Environmental Review Team Report

Indian Springs Subdivision

Killingworth, Connecticut

ENVIRONMENTAL REVIEW TEAM REPORT
ON
INDIAN SPRINGS SUBDIVISION, SECTION I
KILLINGWORTH, CONNECTICUT

PROPOSED PLAN
INDIAN SPRINGS
SUBDIVISION
SECTION I

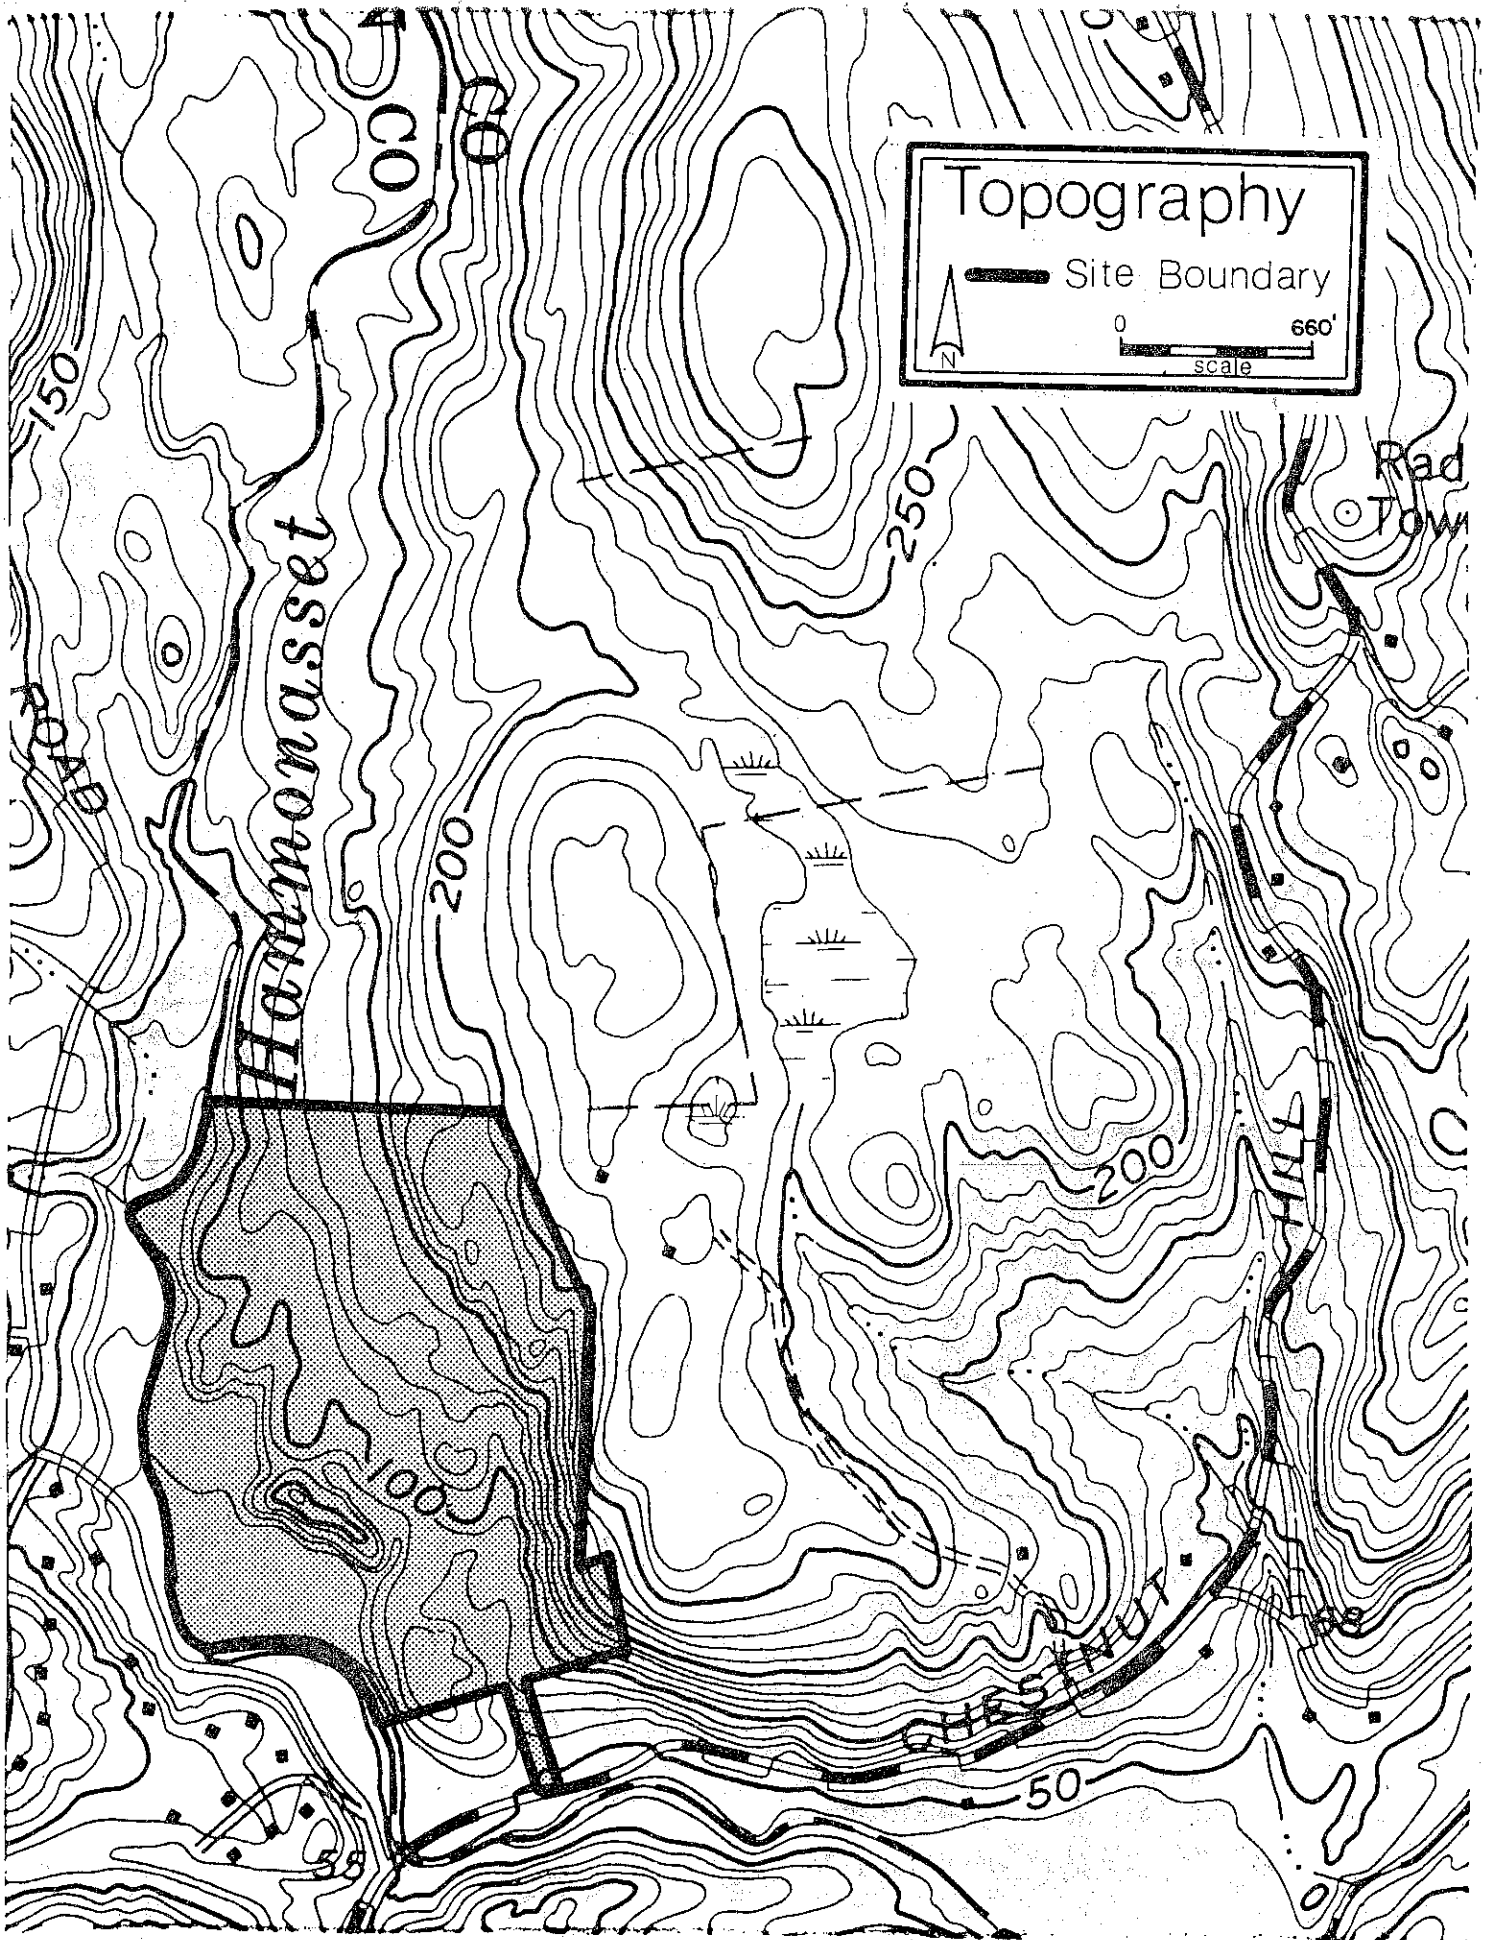
Plans which were reviewed by the Team appeared to be very general. Minor drainageways had not been considered in the planning process, also details for stabilization of relocated streams had not been addressed. A detailed sediment and erosion control plan, to be implemented during construction, should also be submitted with final plans.

During the field review, Team members expressed concern that the proposed road layout did not seem to follow the site's better terrain, but rather crossed the former landfill area, over several ledge outcrops, up the steeper slopes and through the best area of tree cover. The proposed road does not follow the site's general contour or the existing unpaved road which runs parallel to the river along the site's

flat terrain. Location of this road will cause major disruption on the site and in the landfill, which must be partially excavated before construction. Of additional concern is the future location of driveways on lots 8-15 which may require steep access ways.

Water supply is a major concern in this proposal, primarily because on-site wells will be used to produce water for the proposed lots and there is a strong possibility of groundwater contamination from the former landfill. Proposed Lot #2 would be subject to a high risk of leachate pollution. A more detailed explanation of potential ground water problems is found in the Water Supply section of this report. Septic system installation and proper functioning is also questionable in some areas of this site.

Due to the number of questions which have arisen in response to development of Section I of the proposed Indian Springs subdivision, town commissions may wish to require the developer to prove that a potable water supply is available on the lots in question. The location and extent of the former landfill should be on all maps of record for this section of the development.

Surficial Geology

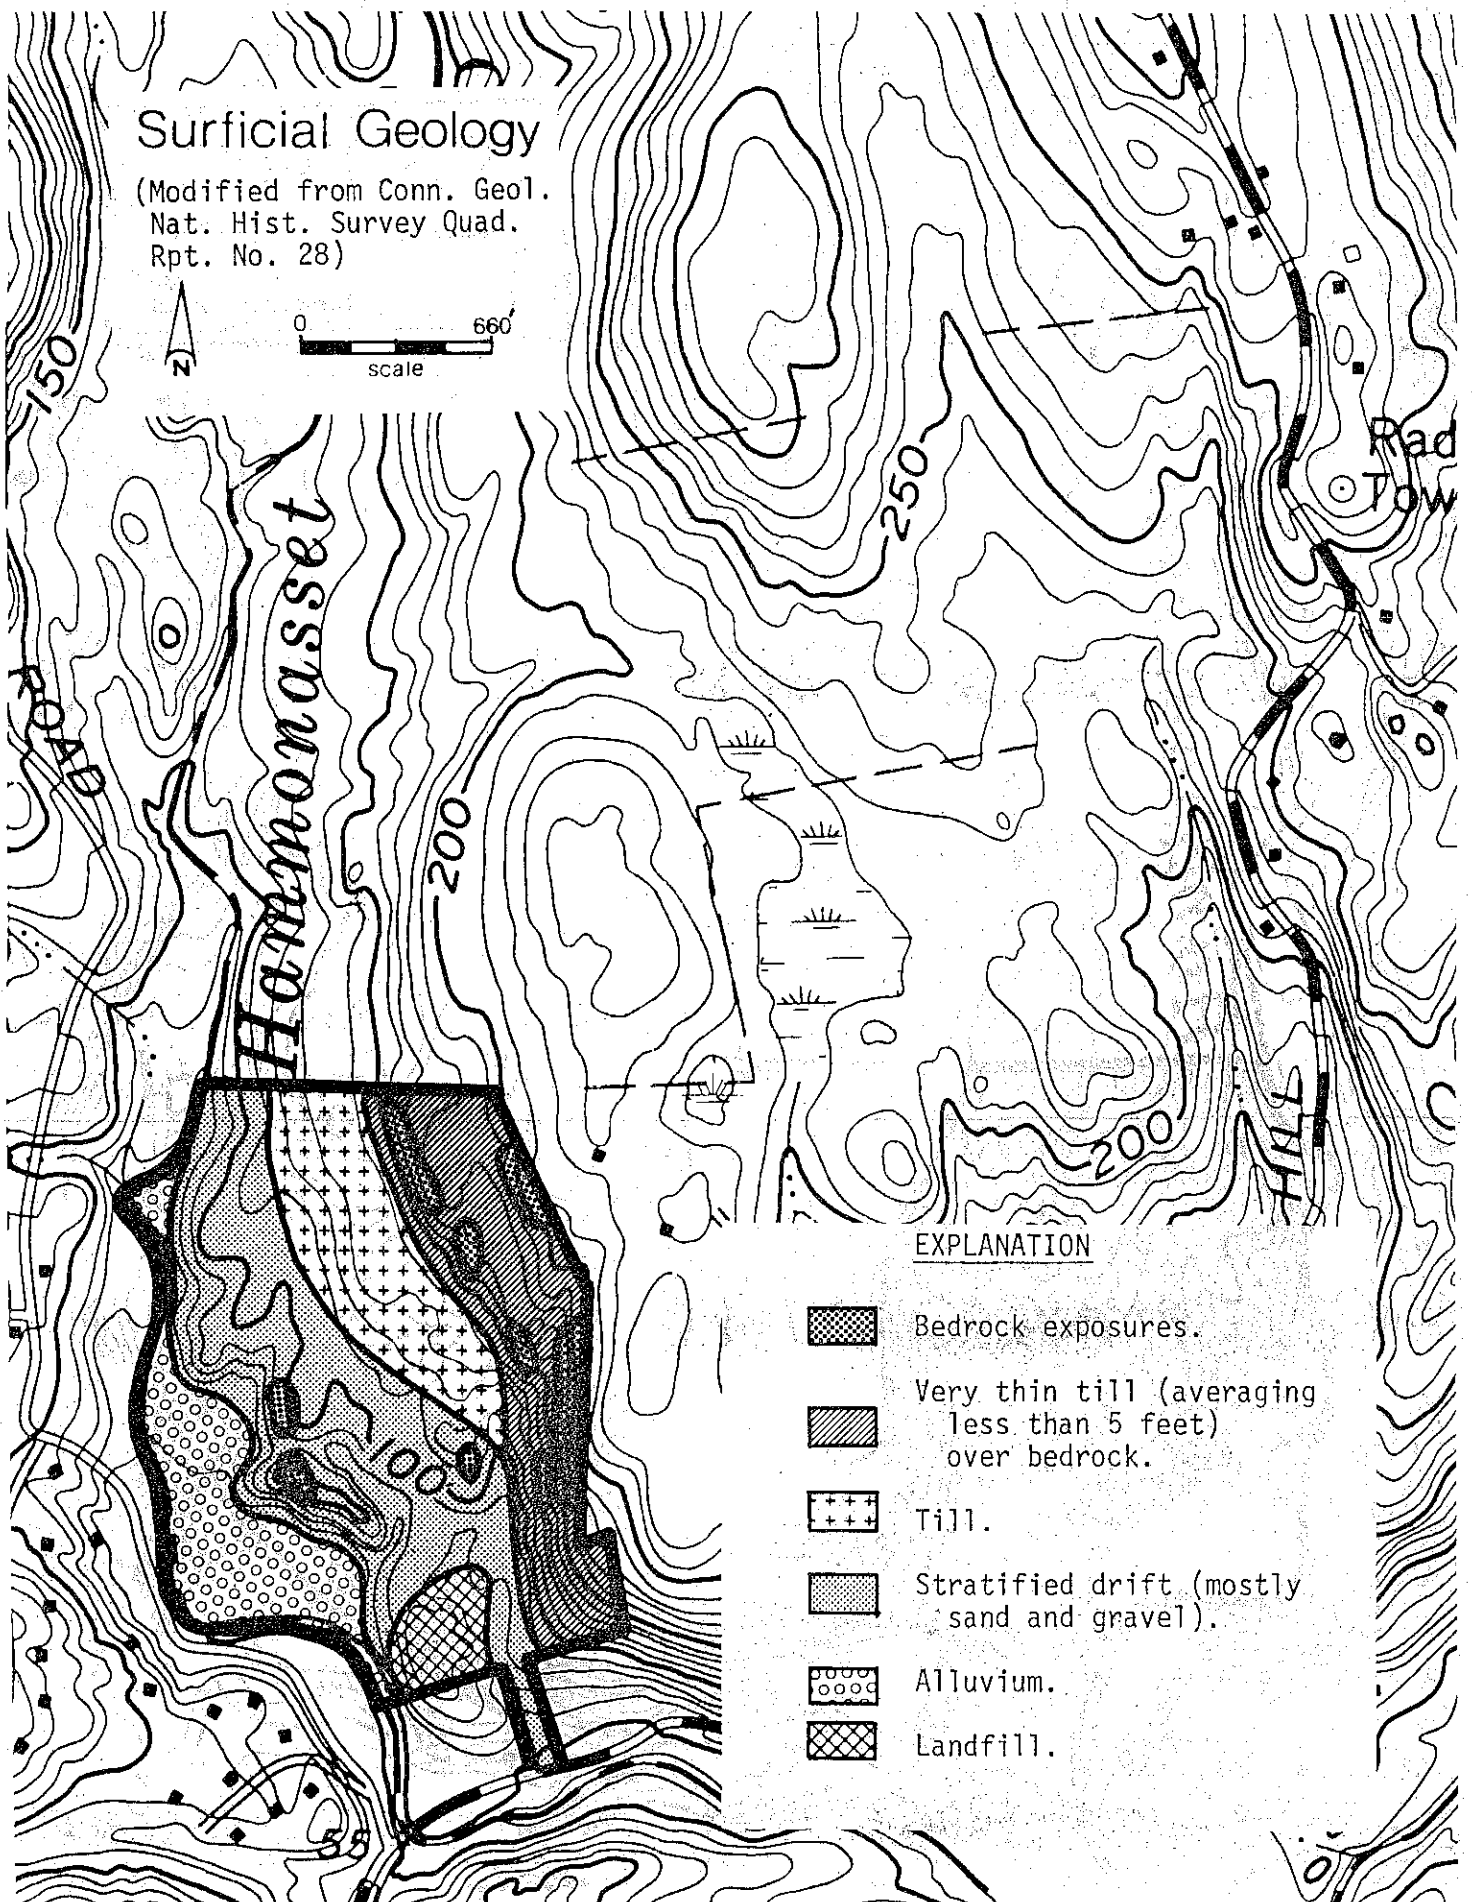
Four major surficial geologic materials are found on the site: till, stratified drift, artificial fill, and alluvium. The approximate distribution of these materials is shown in an accompanying illustration. Till, which is found primarily in the eastern half of the property, consists of a nonsorted mixture of rock particles of widely varying sizes and shapes. These particles were accumulated and transported by glacier ice, and were redeposited directly from the ice without substantial re-sorting by meltwater. The texture of the till is commonly sandy, stony, and relatively loose in the upper few feet, but it is often siltier and compact at greater depths. In a 200-foot to 400-foot wide strip along the eastern boundary of the site,

bedrock crops out conspicuously, suggesting that the average thickness of the till is less than 5 feet. To the west of that strip, northeast of the gravel pit, the average till thickness probably is greater than 5 feet.

Stratified drift is a glacial sediment composed largely of sand and gravel, which were deposited by meltwater flowing from a wasting body of ice. Most of the stratified drift on the site has been excavated, leaving a large open pit in the central section. The area designated as artificial fill on the accompanying geologic map is largely composed of material excavated from this pit. The remainder of the fill is solid waste dumped by the town in previous years.

FLOOD HAZARD AREA

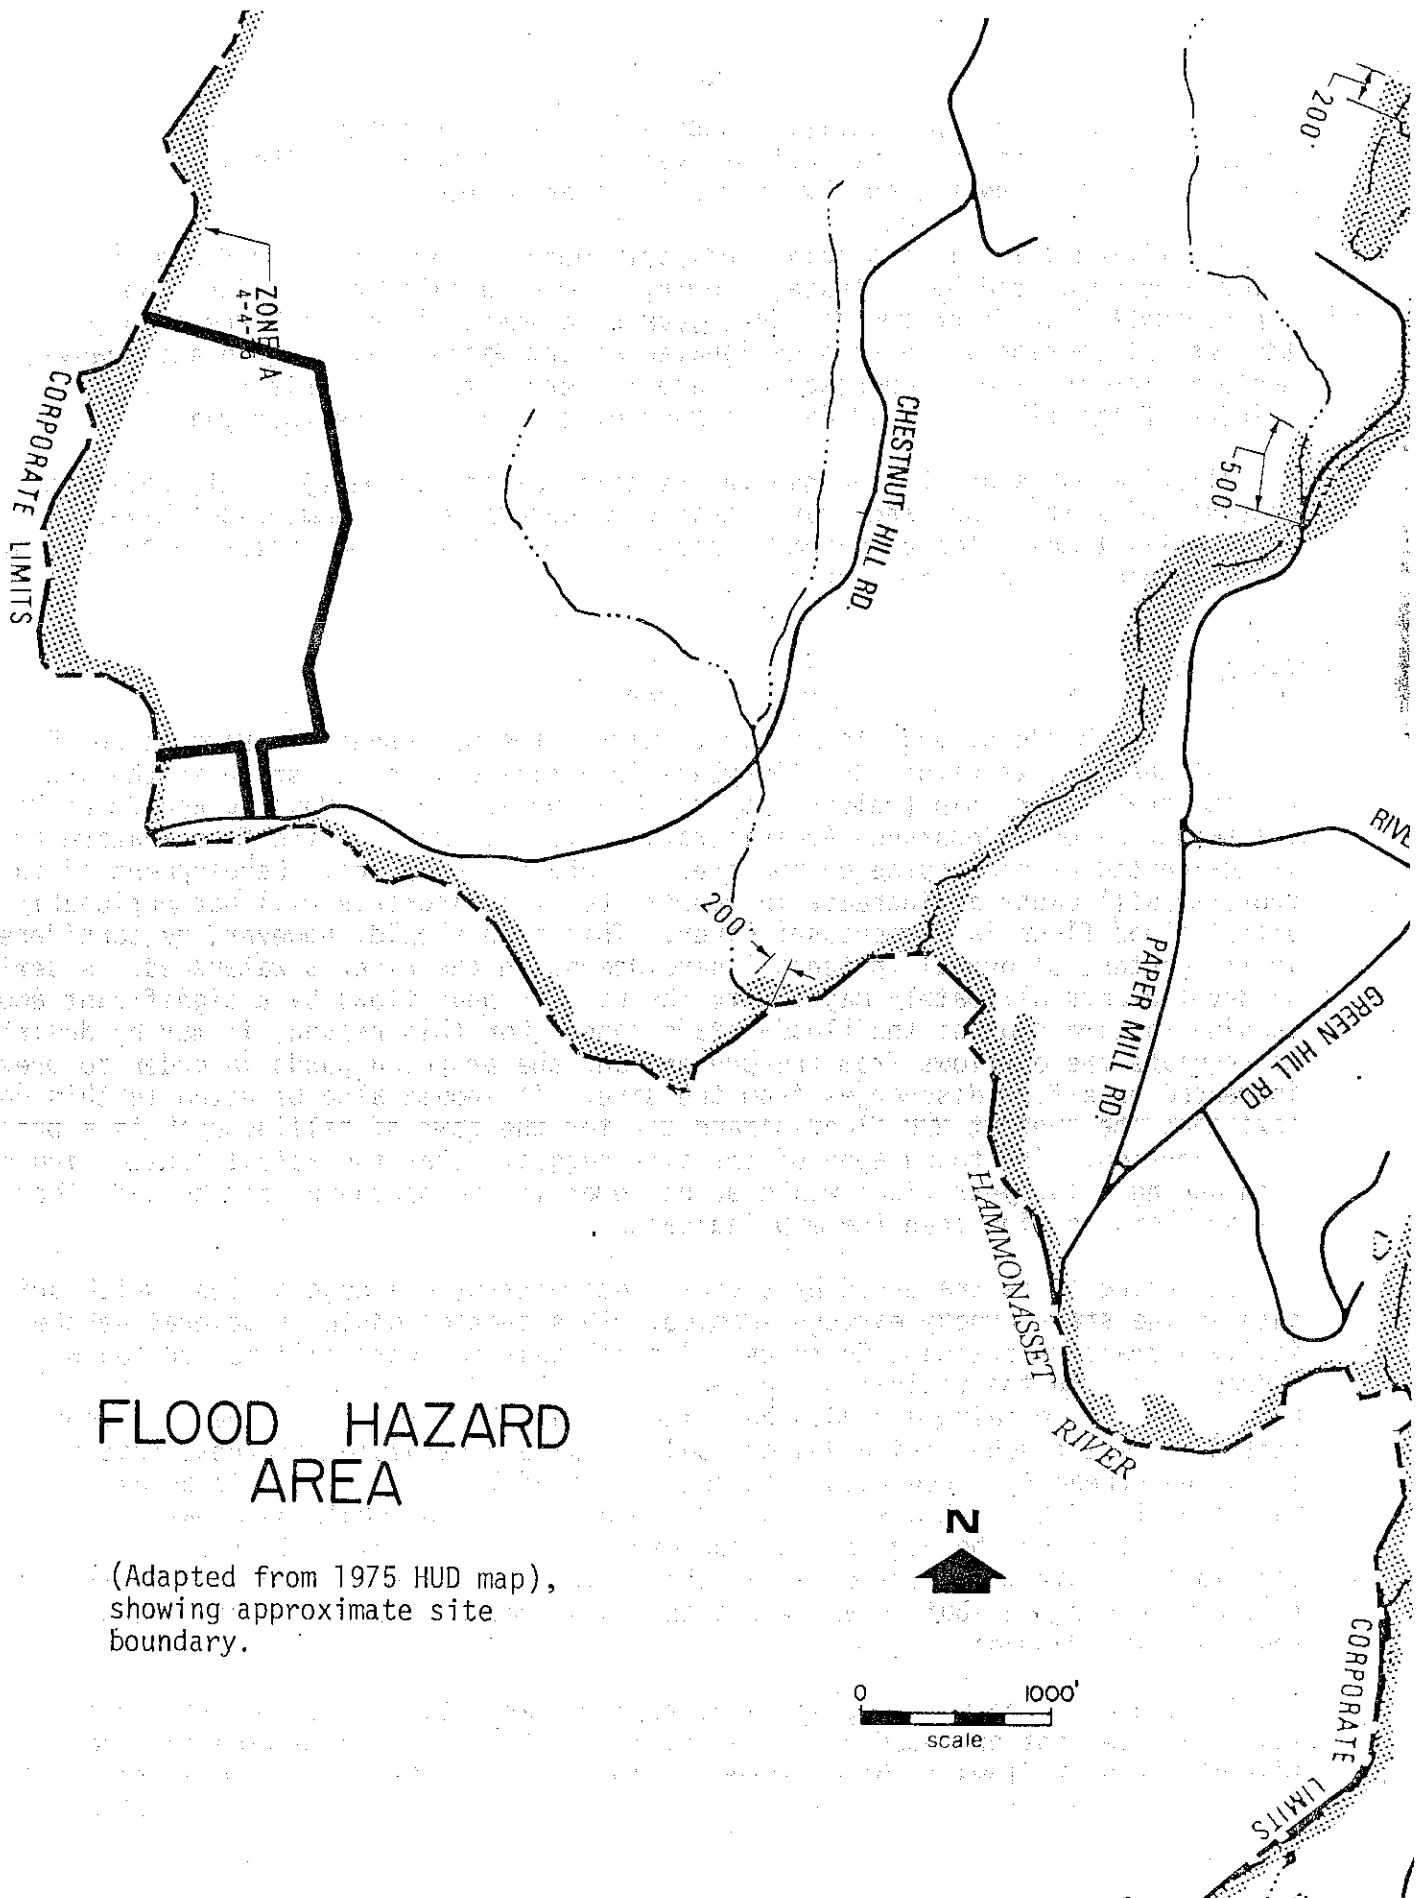
The site borders, and lies entirely within the watershed of, Hammonasset River. Part of the site is within the 100-year-flood hazard zone, as shown in the accompanying preliminary map (released by the U.S. Department of Housing and Urban Development, Federal Insurance Administration, 1975). Most of the flood-hazard area is designated as open space on the present subdivision plans. Development of the property will cause an increase in runoff, but this increase will not noticeably affect flood flows in Hammonasset River. This plan should, however, be considered in the context of overall potential development in the river's watershed. A series of developments ultimately may add to the river's peak flows by a significant amount, causing an expansion of the flood-hazard zone. For this reason, it may be desirable to regulate the outflows from the present and the proposed ponds in order to prevent increased peak-flow discharges from the site. It should also be noted in this context that the present HUD flood-hazard map for the town of Killingworth is a preliminary version. The topography of the site suggests that the actual zone of inundation during a 100-year flood would be narrower in the northern section and wider in the southern section than the map indicates.

Vegetation

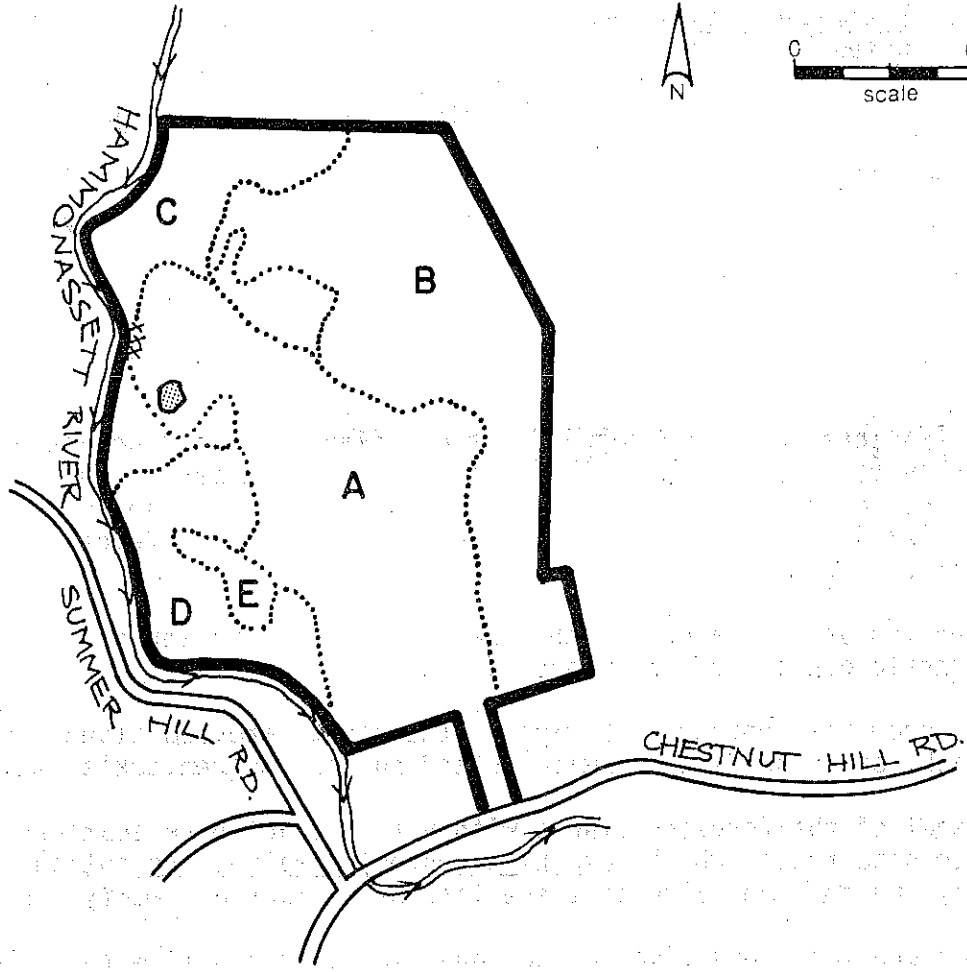
Windthrow is a potential hazard in stand type B (Mixed hardwoods). The trees in this stand are unable to become securely anchored in the shallow to bedrock soils present. In some places the steep slopes intensify this hazard. If the underlying bedrock is highly fractured, the windthrow hazard will be lessened because tree roots may be able to penetrate deeper for more stability. Clearing operations in this stand should be limited, because large clearings may allow wind to pass through rather than over this stand, increasing the already high windthrow potential.

It should be noted that a sudden exposure to direct sunlight and the increased soil temperatures caused by clearing may injure or cause mortality in the residual hemlock trees in stand types C and D. Once again hemlock, because of their shallow and sensitive root systems are very susceptible not only to windthrow but also to damage caused by changes in micro-climate brought about by clearing for construction.

Planting several rows of hemlock in the area designated on the Vegetation type map, would eventually help to shade the Hammonasset River, protecting it from the direct sunlight which it is receiving at present. These trees should be planted approximately ten feet apart in two or three staggered rows.
